TECHNICAL BULLETIN INDEX
Sorted by Bulletin Number
04/03/86

BULLETIN NO: II:1

PRODUCT: 26-4001/2 Model II

Figure 1

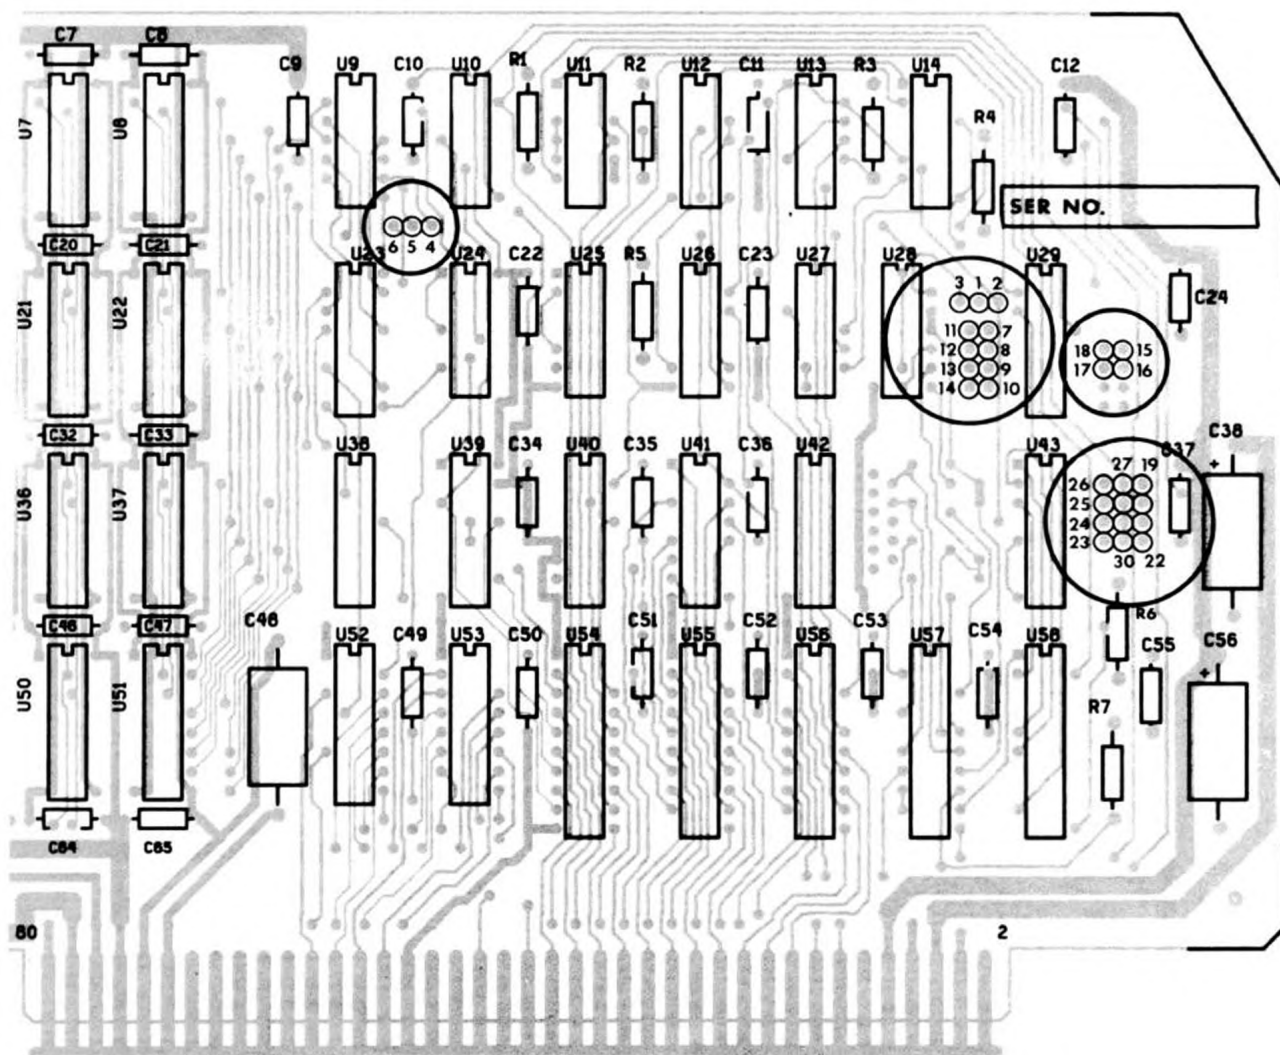
PURPOSE: To correctly identify proper jumper configurations for the Model II Memory Boards.

DISCUSSION: There are three possible memory board configurations for the Model II. A 32K Ram board, a second 32K Ram board to upgrade from 32K to 64K Ram, and a single 64K Ram board* Jumper configurations are different for each board.

16-17 Selects the first 16K of the base page
15-18 Selects the second 16K of the base page

26-27 Enables the next jumpers on page 1 of the memory map
9-11 Selects the first 16K of page 1
10-12 Selects the second 16K of page 1

16-17 Selects the first 16K of the base page
15-18 Selects the second 16K of the base page
26-27 Enables the next jumpers on page 1 of the memory map
9-13 Selects the first 16K of page 1
10-14 Selects the second 16K of page 1

1-2 Pulls up an input to U27 that was floating
5-6 Pulls up an input to U9 that was floating

Figure 1

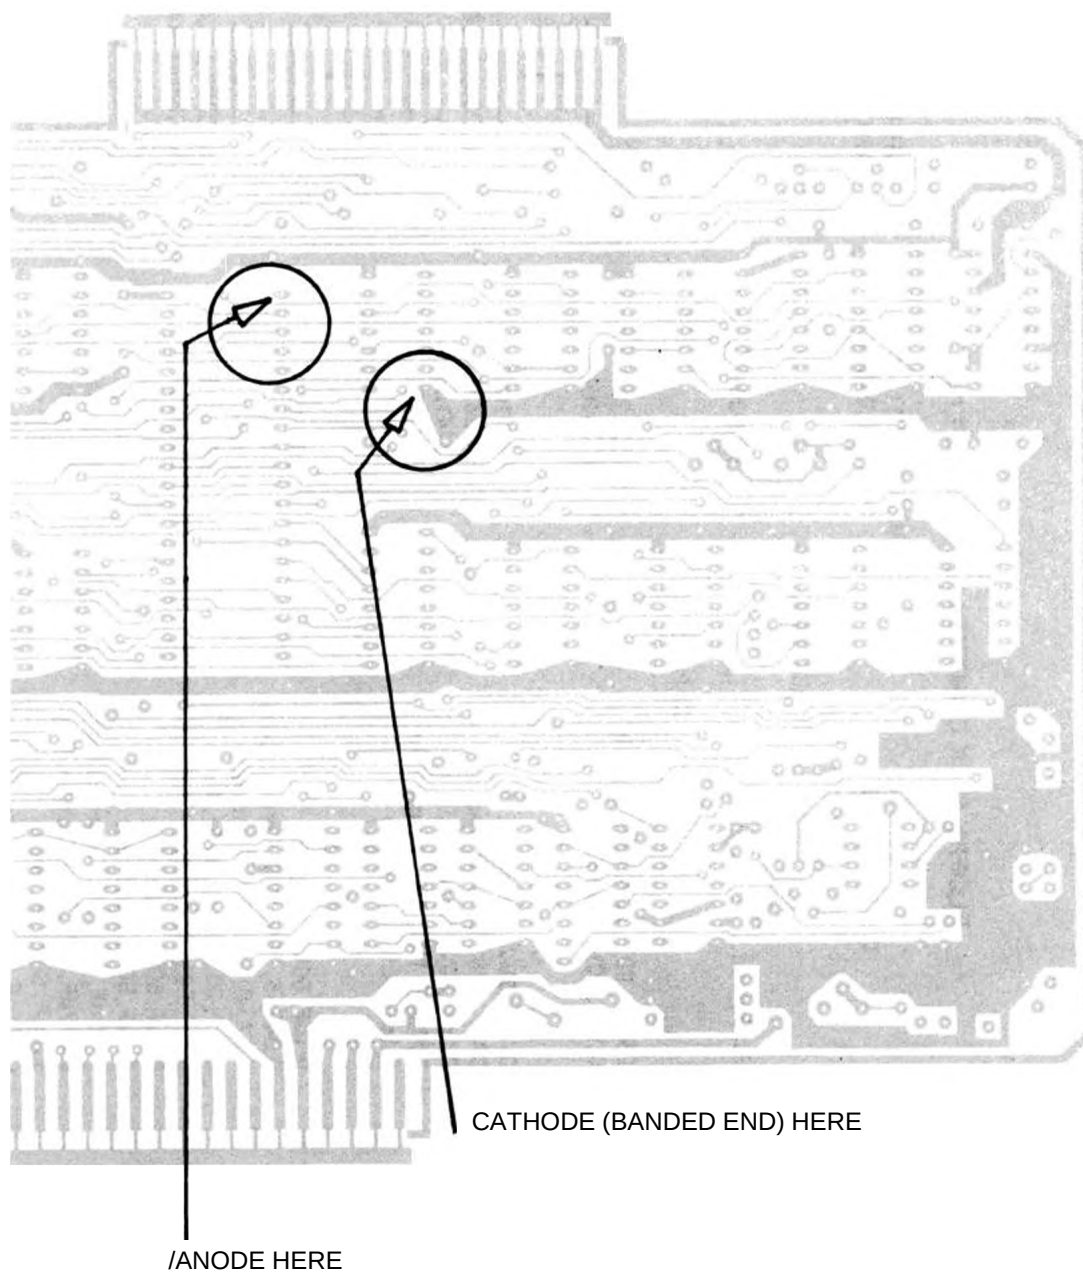
PURPOSE: To correct thermal failure of FDC IC (U6) causing Read/Write errors, and other intermittent disk I/O failures.

DISCUSSION: Early FDC chips developed thermal failures causing disk I/O failures and Read/Write errors. To correct this problem a 2.7V Zener diode MUST be installed from U6 Pin 1 to U5 Pin 7. On new and factory repaired assemblies this change will already have been installed.

PROCEDURE: Check to see if this modification has been done, if not, install diode as per Figure 1. Be sure to use sleeving for insulation of leads to prevent shorts. This diode can be ordered from National Parts using part number ADX-1382 and catalog number 26-4001.

Figure 1

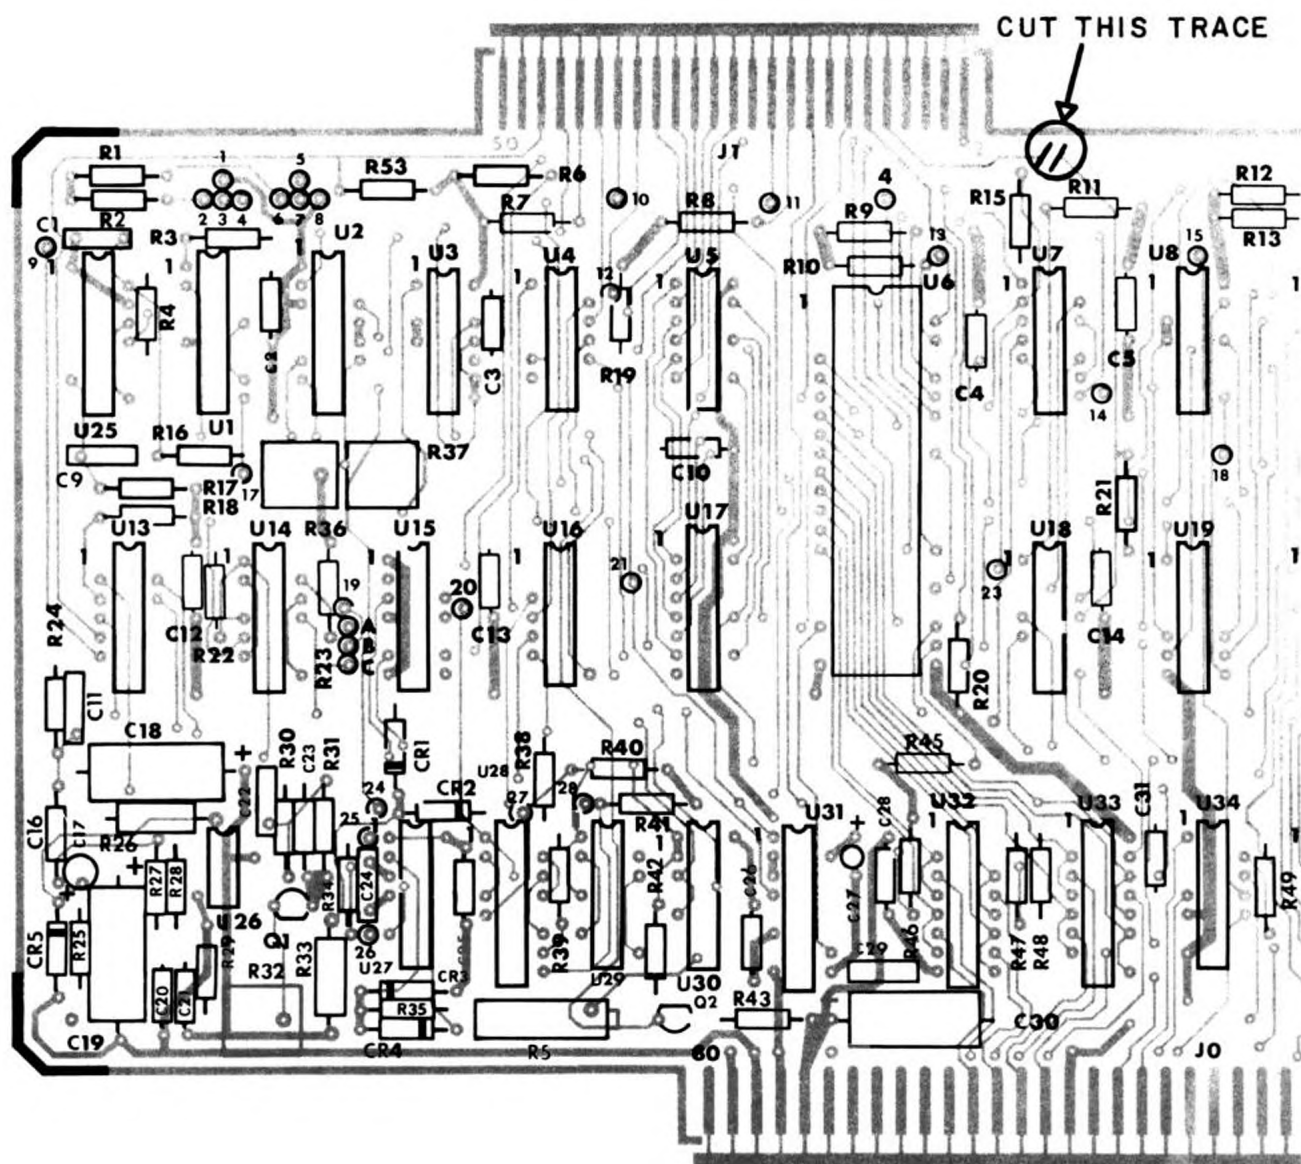
PURPOSE: To prevent Xenix from thinking there is a double sided disk in drive 0 when a terminator is used.

DISCUSSION: The terminator that is used with the Model II ties pin 10 of the disk drive card edge to pin 34. This takes the direction line (pin 34) and connects it to a previously unused line (pin 10) which has a pullup resistor R21 installed on it. Xenix looks at pin 10 to determine if the diskette in the current drive is single or double sided. With the terminator installed this signal will change depending on the direction the drive was last stepped. To correct this problem the trace connected to pin 10 of the FDC board should be cut. This will prevent the customer from being able to use double sided drives, which Radio Shack does not support in the Model II. This modification should only be done to Model IIs that have the 26-6010 enhancement kit installed and an old style FDC board.

PROCEDURE: Locate and cut the trace connected to pin 10 of the disk drive connector on the FDC board (Refer to Figure 1).

FIG 1 OLD PSU WIRING

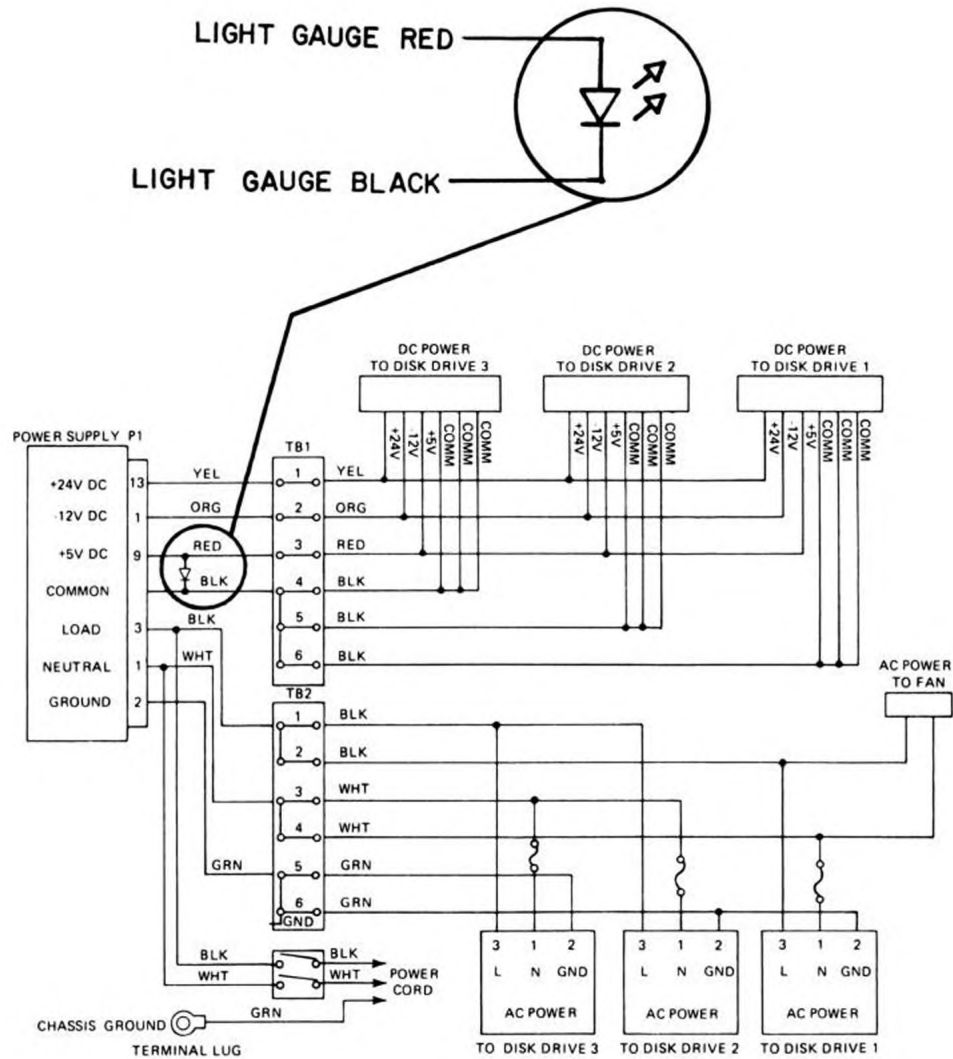
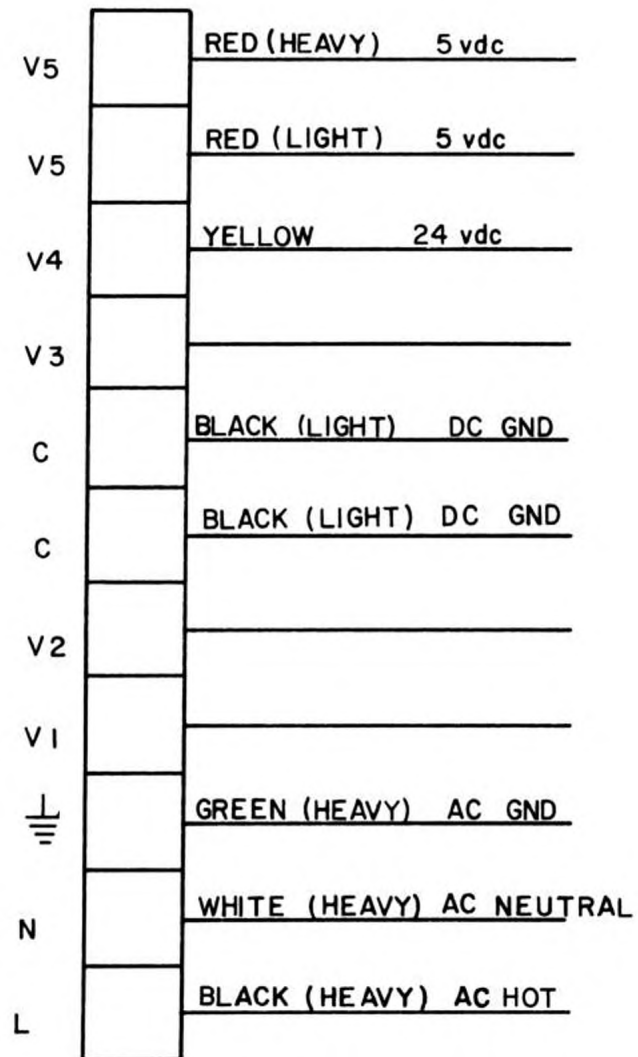
PROCEDURE: Refer to Figure 1 for the early version power supply (closed case) wiring diagram. Refer to Figure 2 for the later version power supply (open case) wiring diagram.

Figure 1

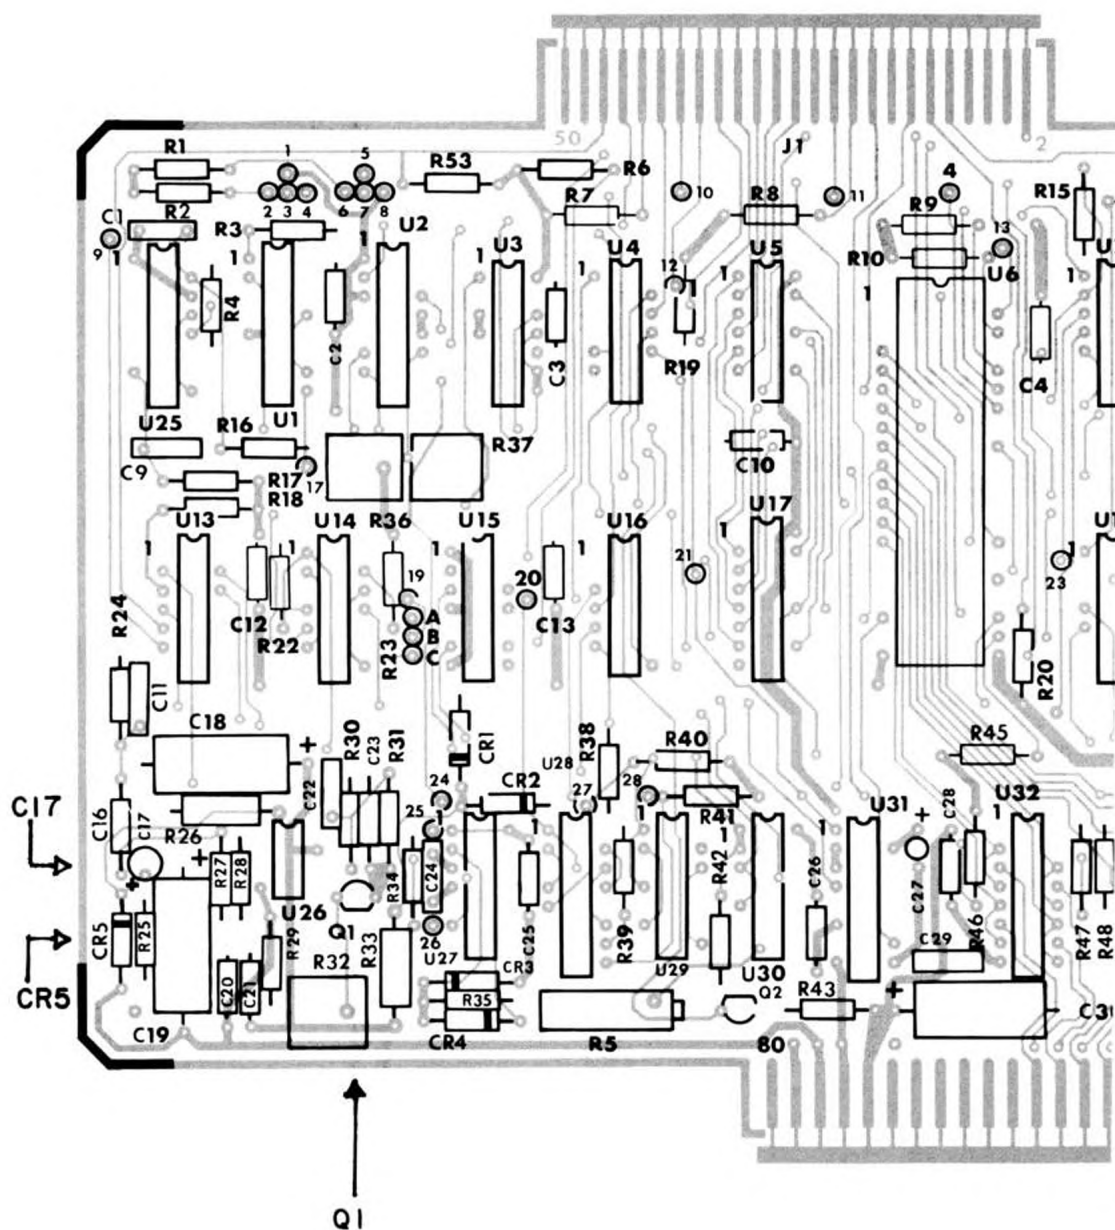
PURPOSE: To correct FDC Boards which have C17 installed backwards.

PROCEDURE: Check C17 on all units in for service to insure the positive(+) lead is going to ground. The most accurate method of checking this is by actually checking with an ohm meter continuity between the positive lead of C17 to ground. If capacitor is installed backwards replace with a new .47ufd tantalum capacitor(ACC-474MGTP). Do not just turn the old capacitor around as it has started degrading and life expectancy shortened.

If the capacitor actually smoked then you must replace it and the diode CR5 (ADX-1279). Also check Q1, a 2N2222A transistor (AMX-4263), because it may have been damaged also, replace if necessary.

FIG. 1

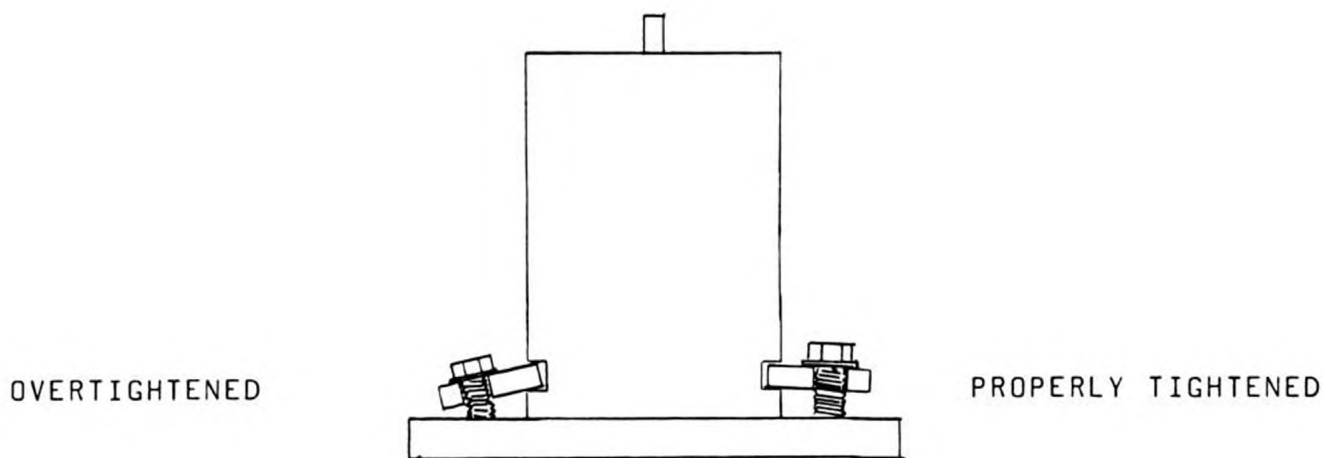
DISCUSSION: After aligning Head Radial DO NOT OVERTIGHTEN bracket screws when securing the stepper motor. Excessive tightening will cause bracket and screws to bend and eventually damage the screw holes in the stepper motor plate, making proper alignment almost impossible.

PROCEDURE: After Head Radial Alignment tighten bracket screws only enough to secure stepper motor. If the stepper motor cannot be secured without excessively bending the bracket (Refer to Figure 1), or if the screw holes in the plate are damaged, replace the drive chassis.

FIG 1

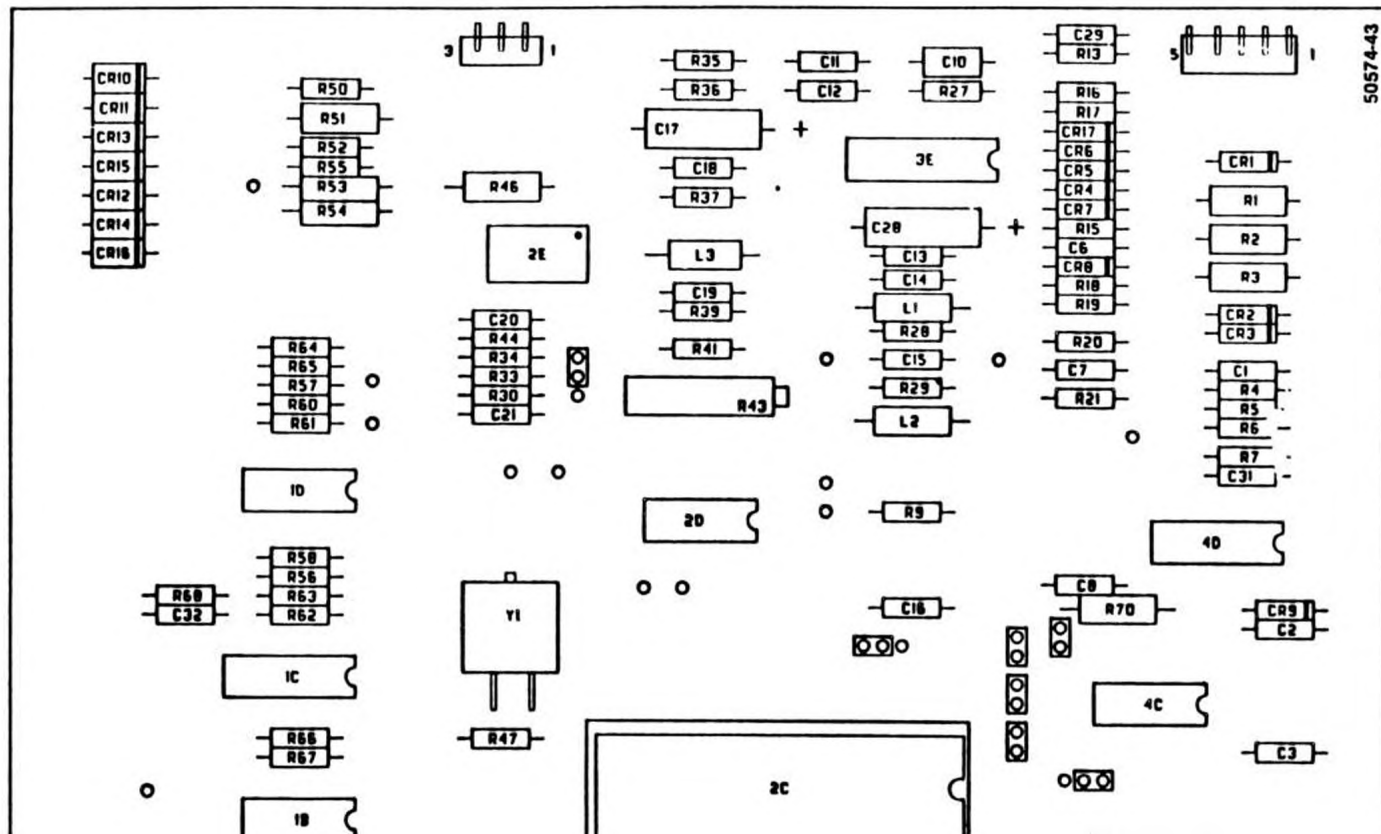
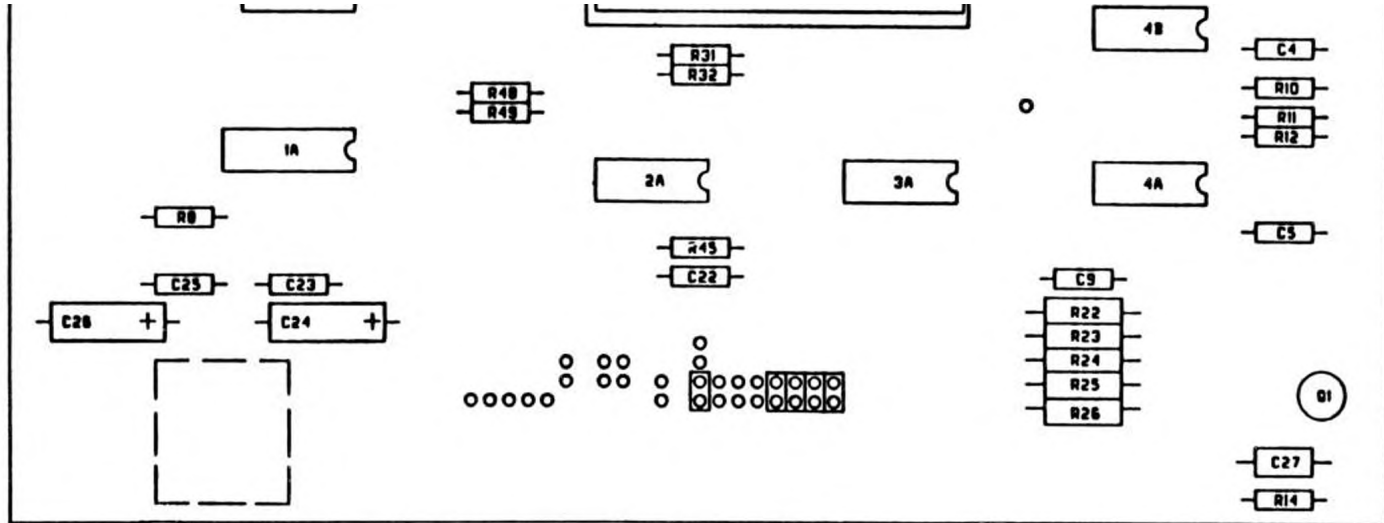
PURPOSE: To correct problem of getting Boot Error DC usually after running Scripsit.

PROCEDURE: SOLUTION 1: Check board to insure .47 ufd capacitor is installed across C21 (Refer to Figure 1). This capacitor should be on all LSI boards, if not present, install capacitor with negative lead going to ground. Any value from .47ufd to .68ufd is acceptable. ACC-474MGTP is the National Parts Number for a .47ufd 35V capacitor. Later boards had the capacitor value at C21 changed.
